MONTGOMERY COLLEGE PROCUREMENT DEPARTMENT

RFP NO.: 626-003

MACKLIN TOWER ROOF REPLACEMENT & LIMITED HVAC UPGRADES, ROCKVILLE CAMPUS RFP CLOSING DATE/TIME: SEPTEMBER 23, 2025 @ 2:00 PM

ADDENDUM #1

AD.10G

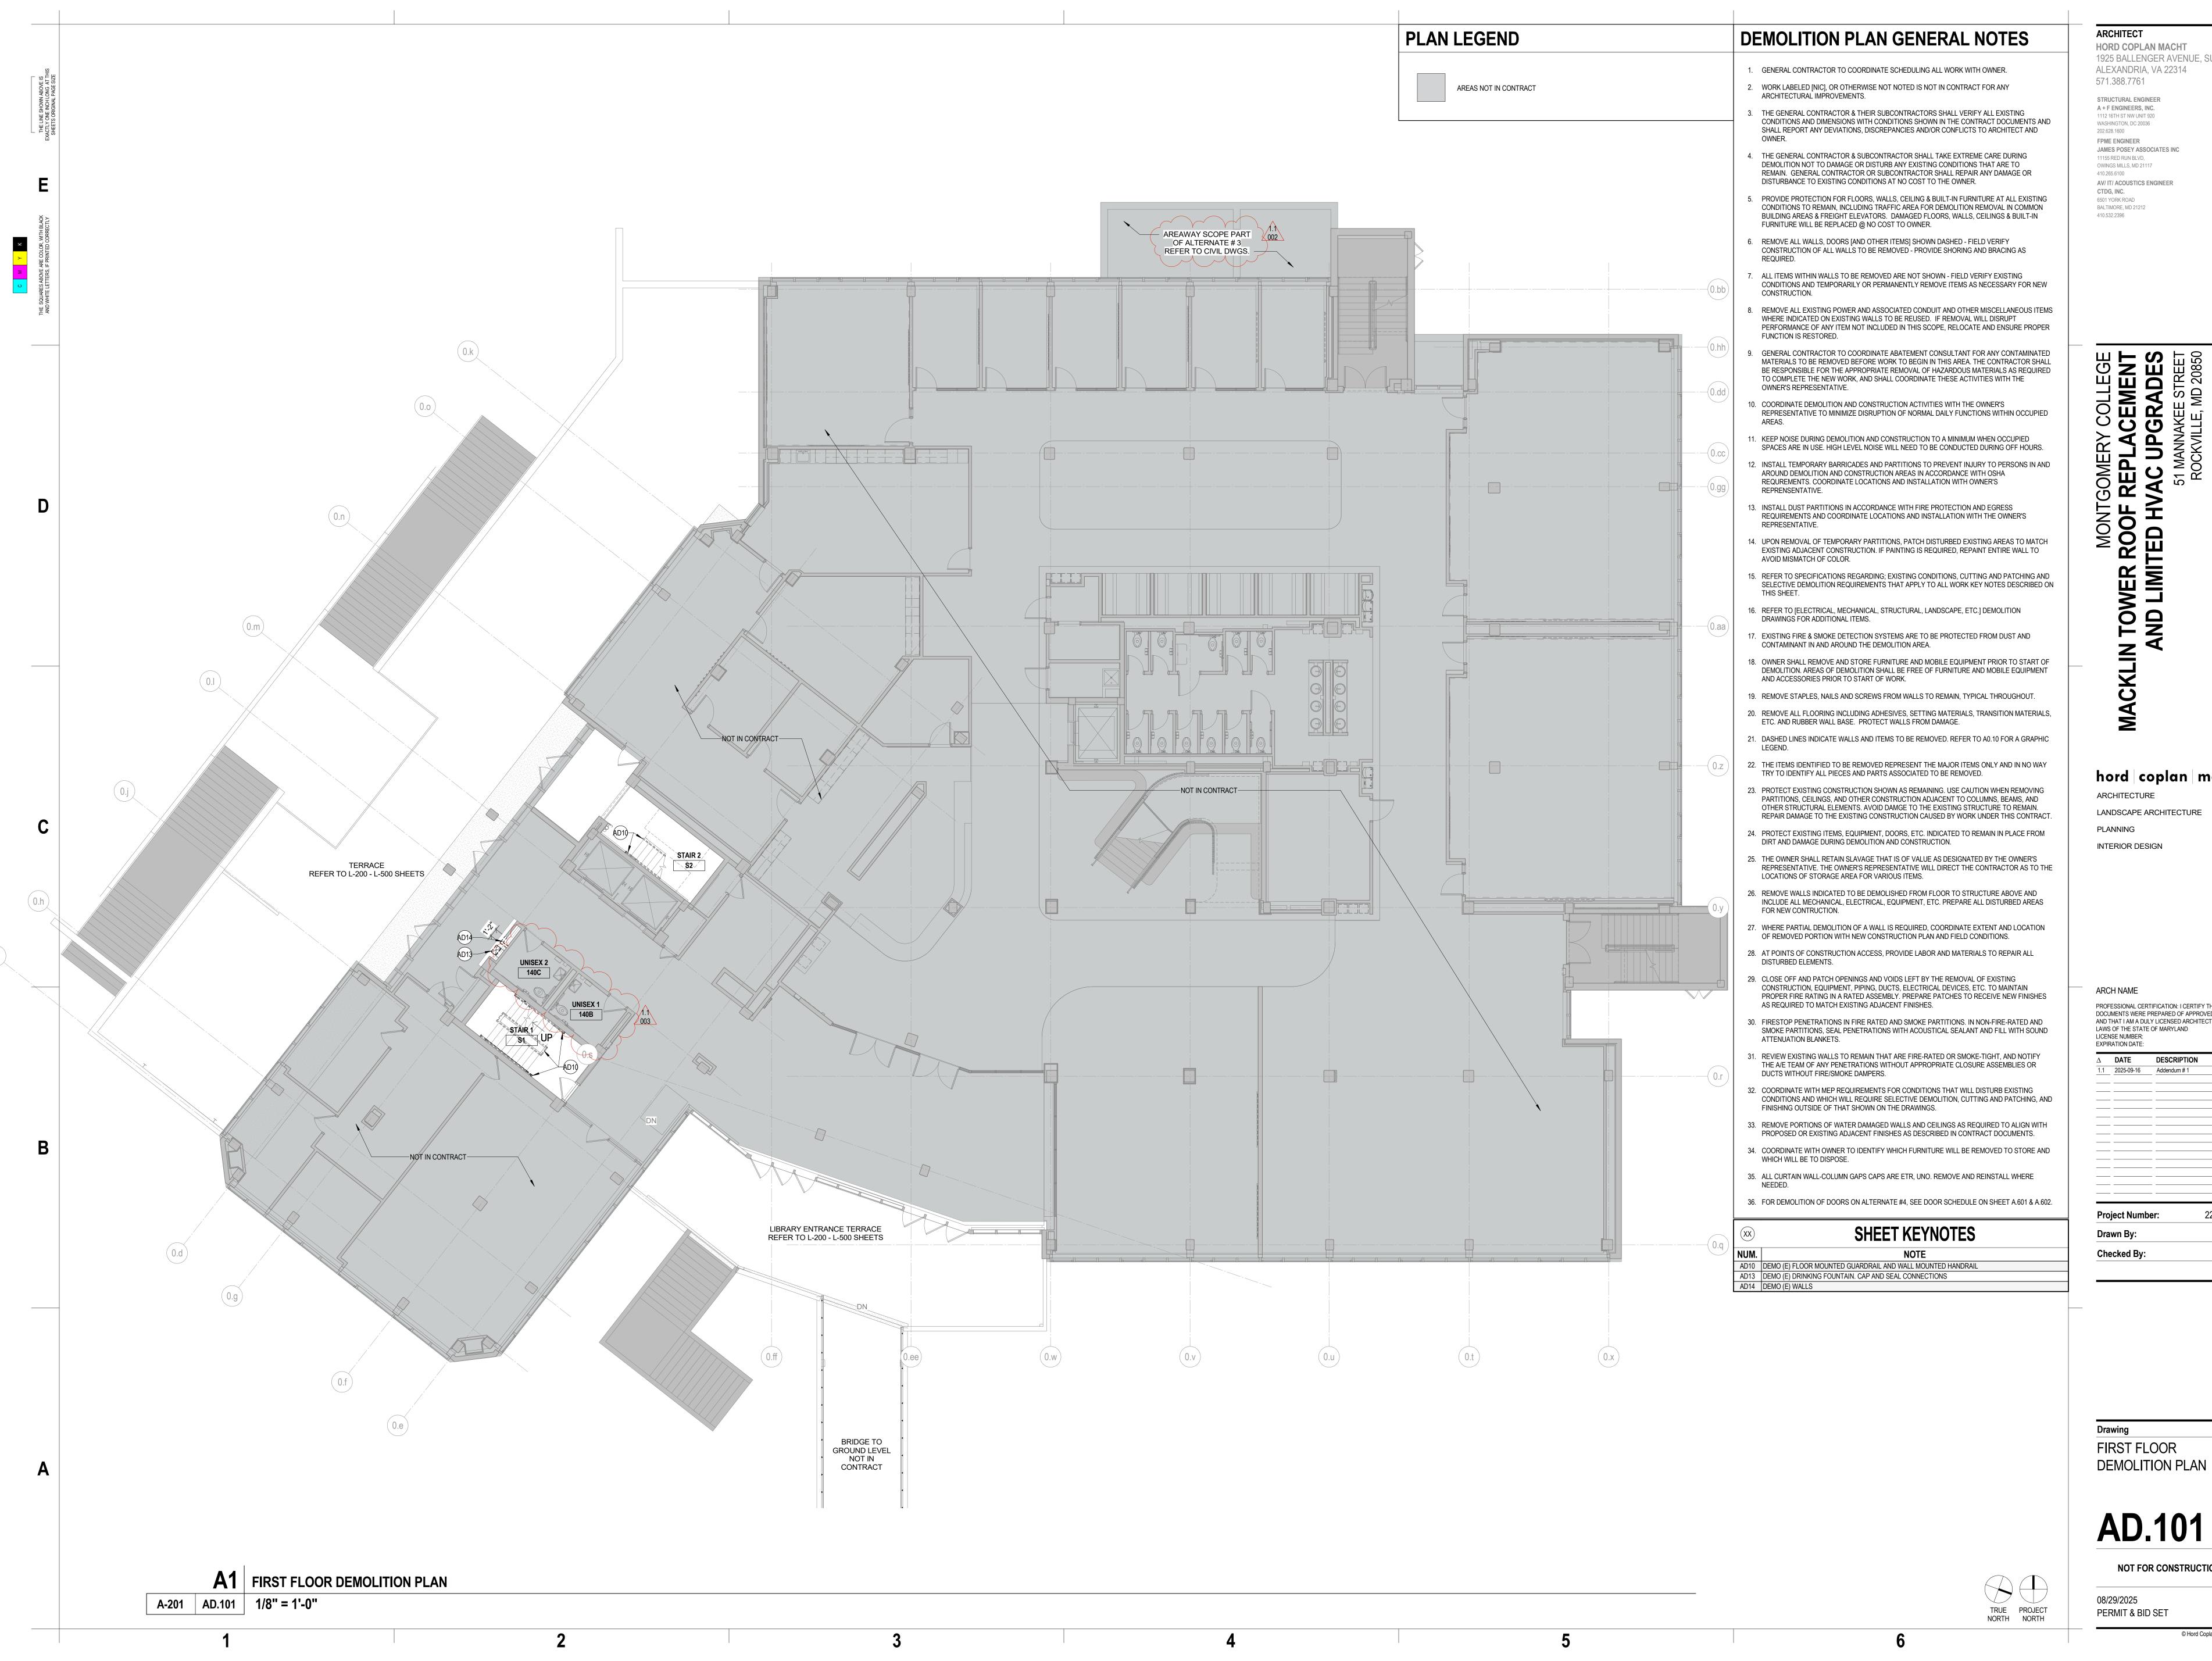
- AD.10G GROUND FLOOR DEMOLITION PLAN
 - 1. Clarified areaway scope. See civil drawings.
- AD.101 FIRST FLOOR DEMOLITION PLAN
 - 1. Clarified areaway scope. See civil drawings.
 - 2. Moved unisex restroom in Level 1 from Roof to Library Project.
- AD.103 THIRD FLOOR DEMOLITION PLAN
 - 1. Clarified Terrace #3 scope. See roofing drawings (AR series).

FIRST FLOOR DEMO REFLECTED CEILING

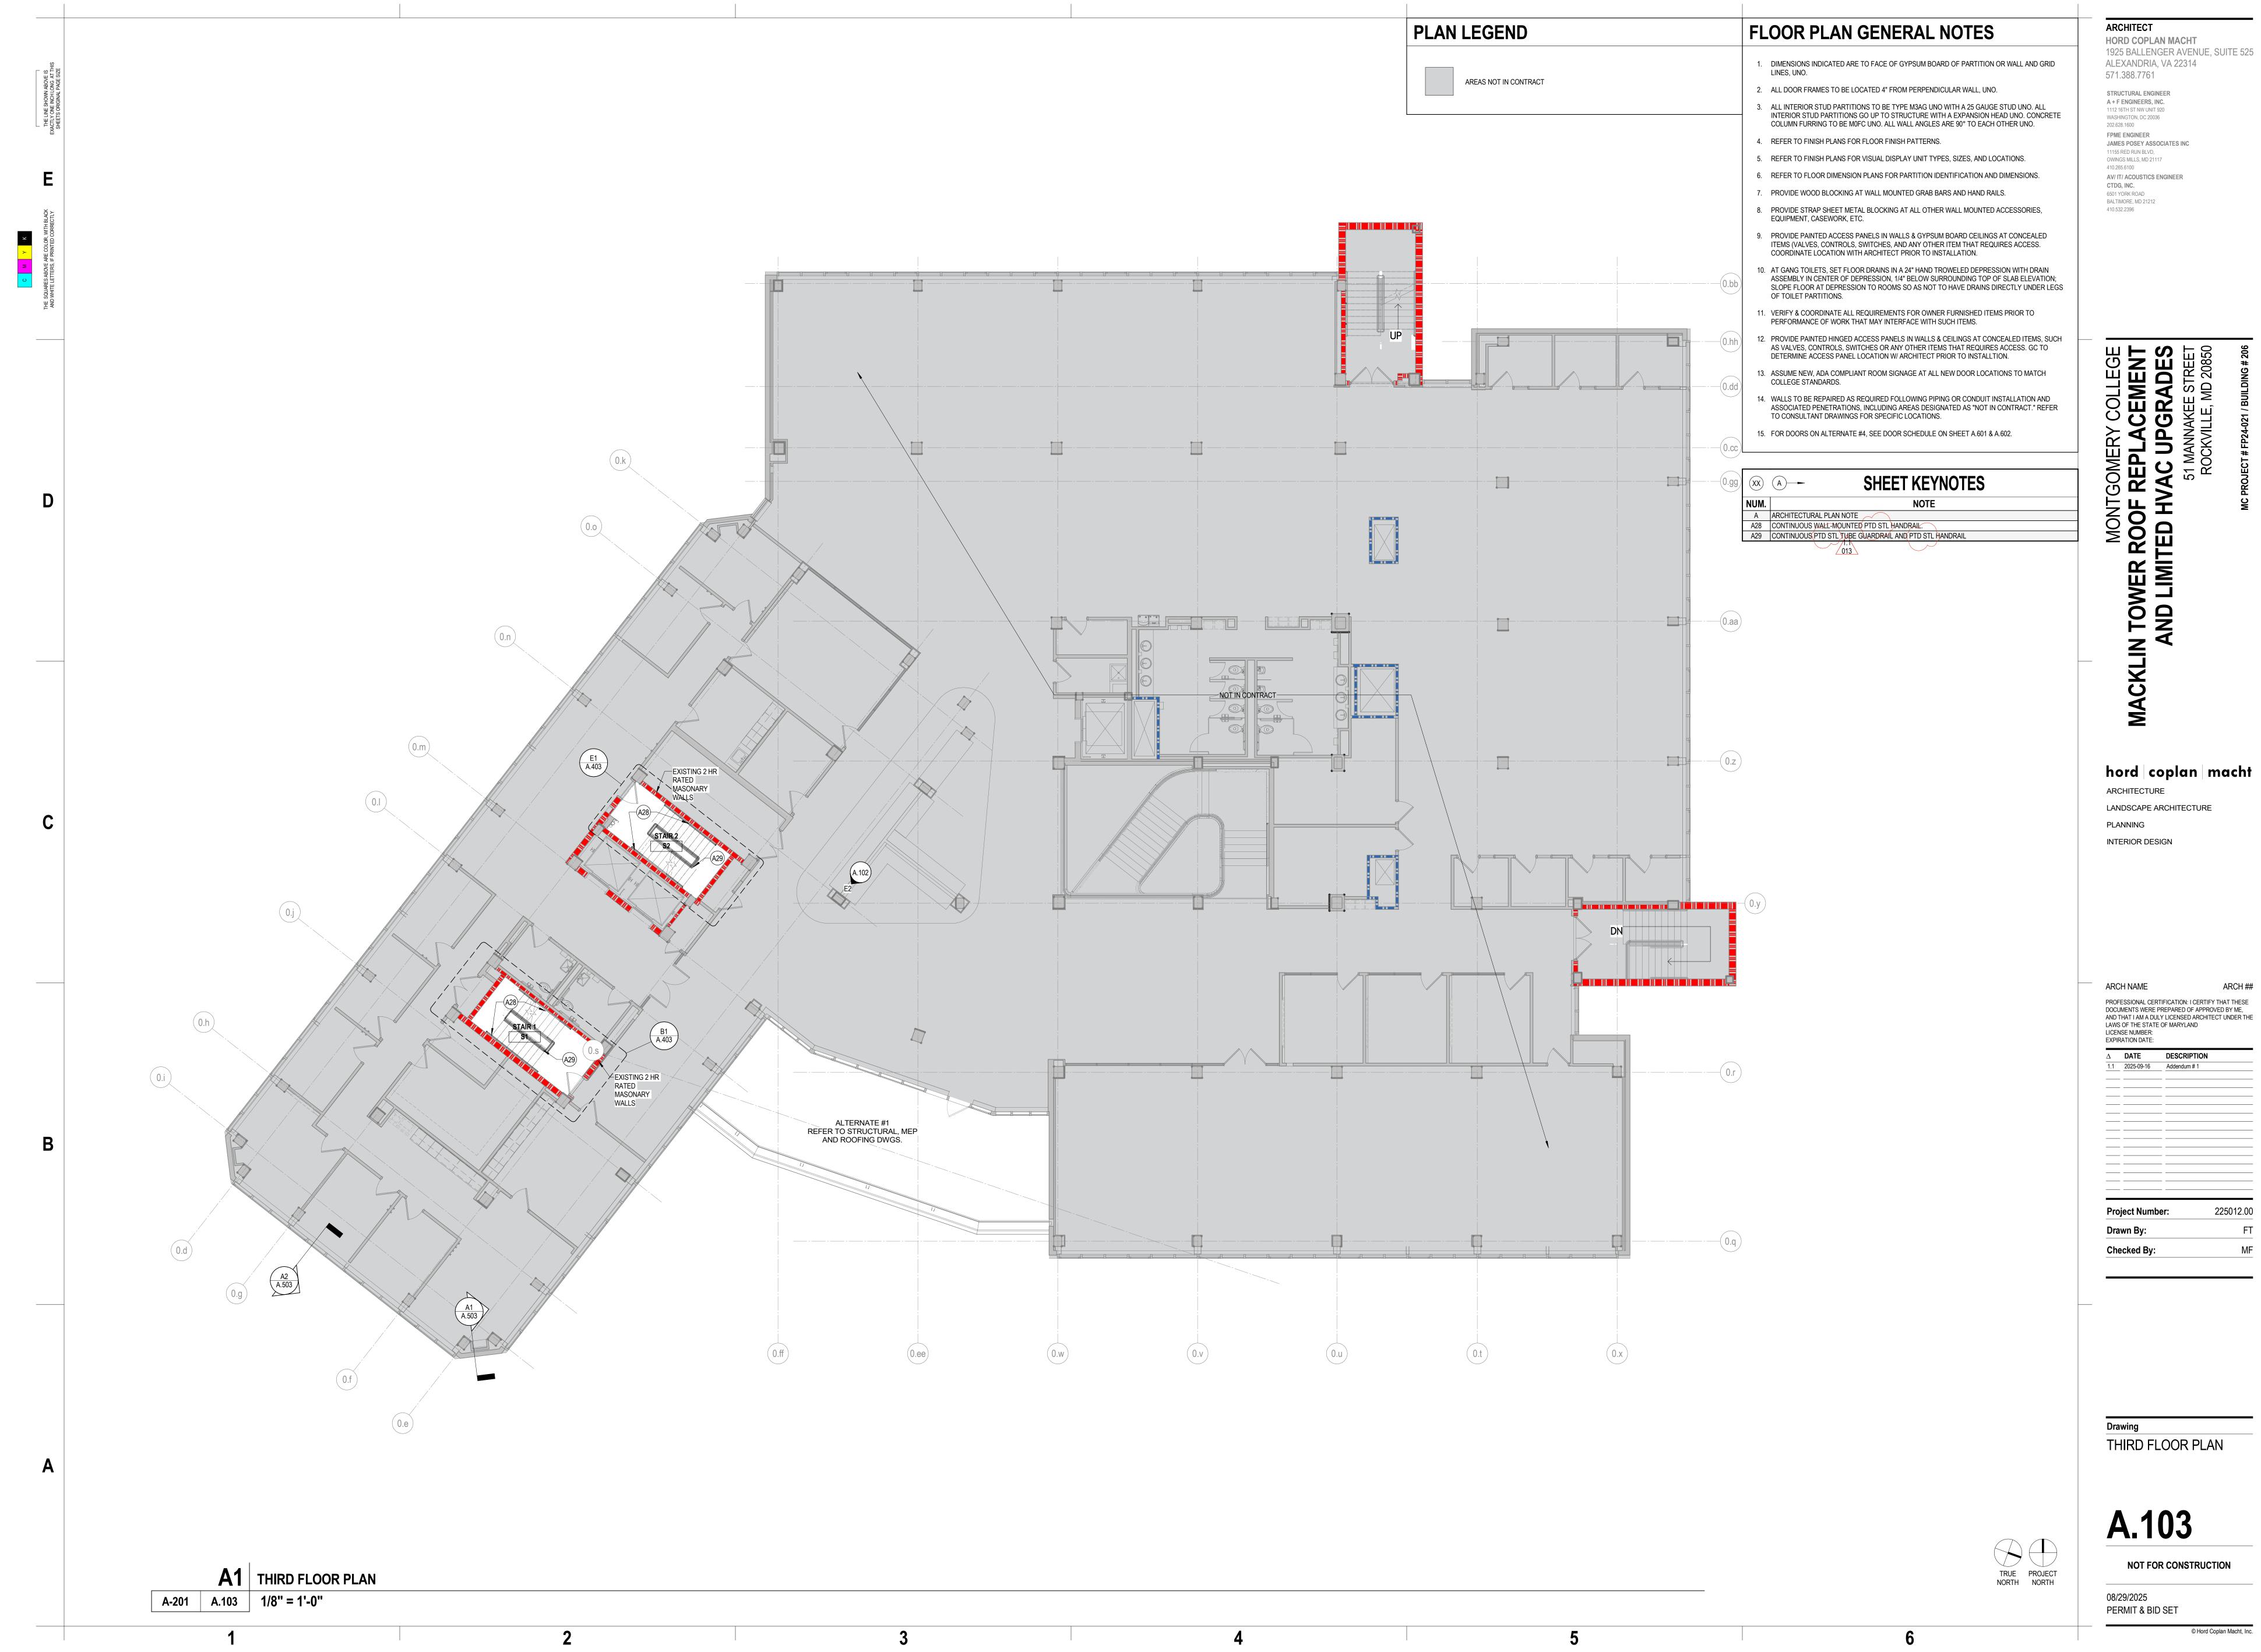
- 2. Added roof replacement sequencing general notes for coordination with Library Project.
- AQ.101 FIRST FLOOR DEMO REFLECTED CEILING PLAN
 - 1. Moved unisex restroom in Level 1 from Roof to Library Project.
